IF ORIGINAL COMPRESSOR DID NOT HAVE A
 COMPRESSOR SOLID STATE MODULE - MUST REWIRE
 THE COMPRESSOR RESET CIRCUIT (115V CIRCUIT)
 (ORIGINAL CIRCUIT)

REVISED COMPRESSOR RESET CIRCUIT (COMPRESSOR WITH
 SOLID STATE COMPRESSOR MODULE)

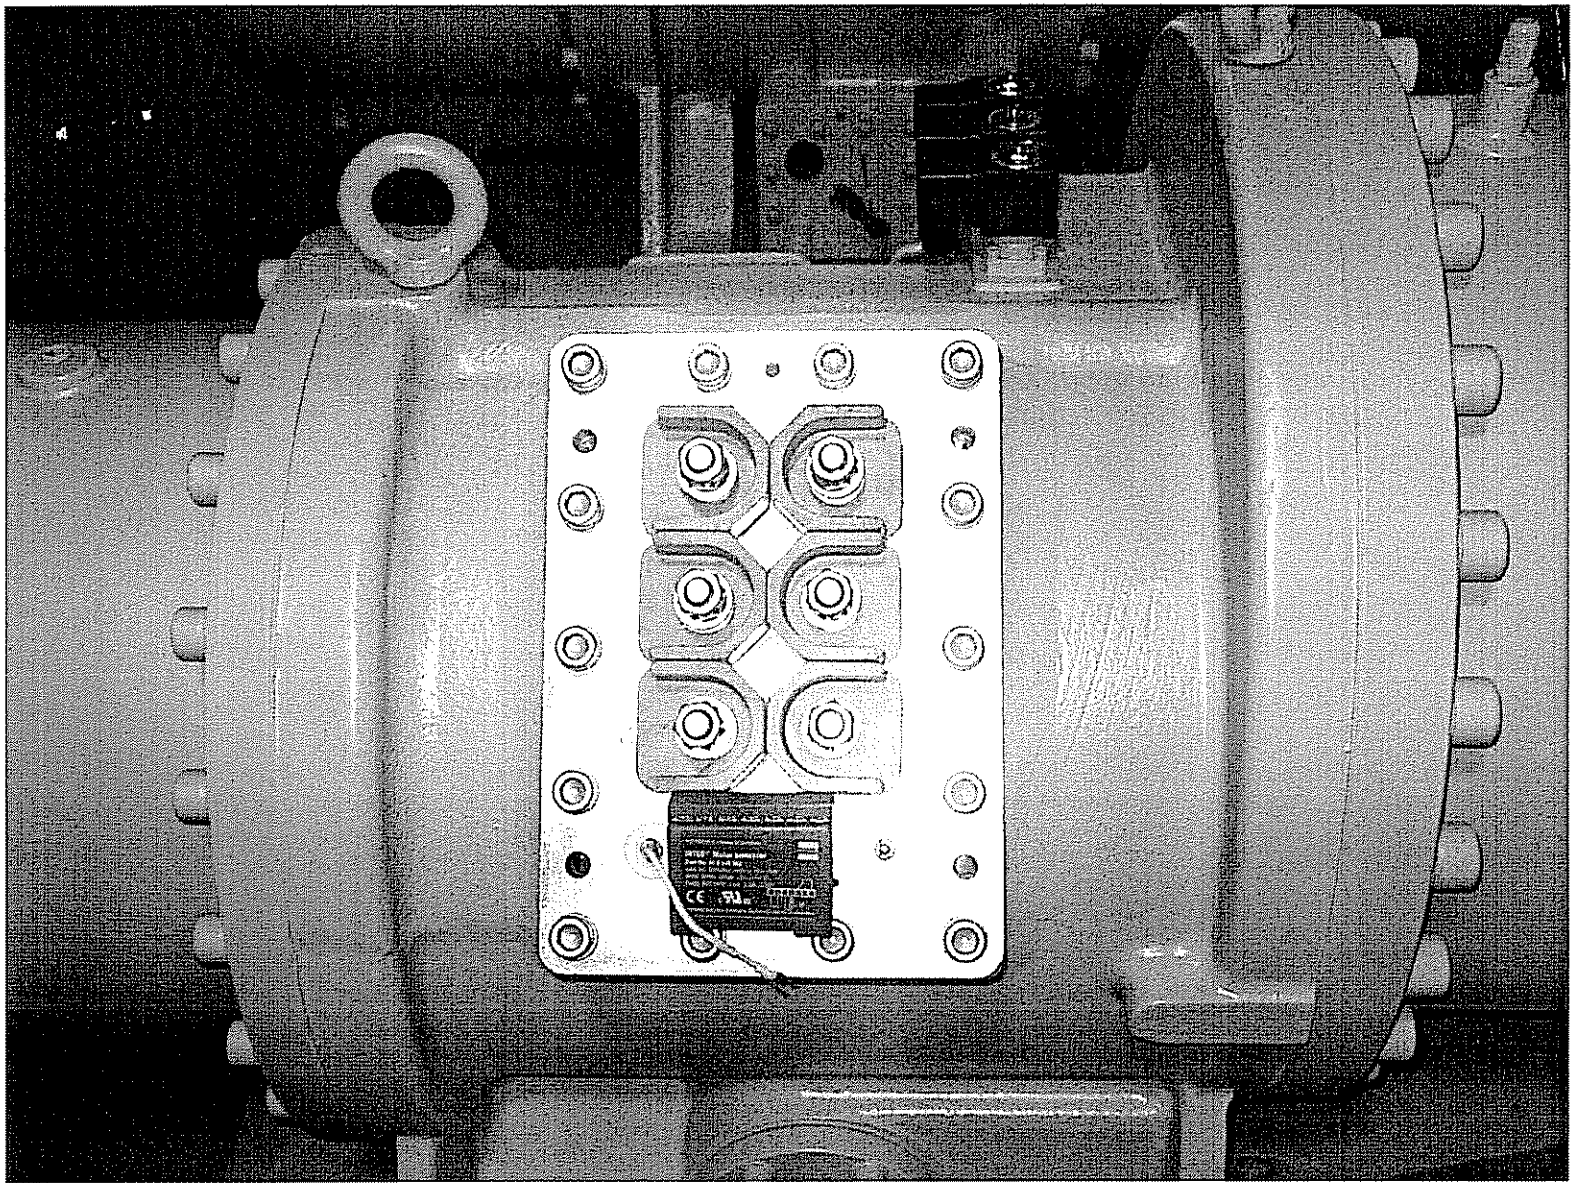
A - OIL FLOAT TERMINALS LOCATED ON BACK SIDE OF
 COMPRESSOR ON OIL SUMP COVER

B - MUST ADD TIME DELAY RELAY (30714123) TO UNIT
 CONTROL

RESISTANCE (WITHOUT SOLID STATE COMP. MODULE) = 0.5Ω

RESISTANCE (WITH SOLID STATE COMP. MODULE) = 260Ω
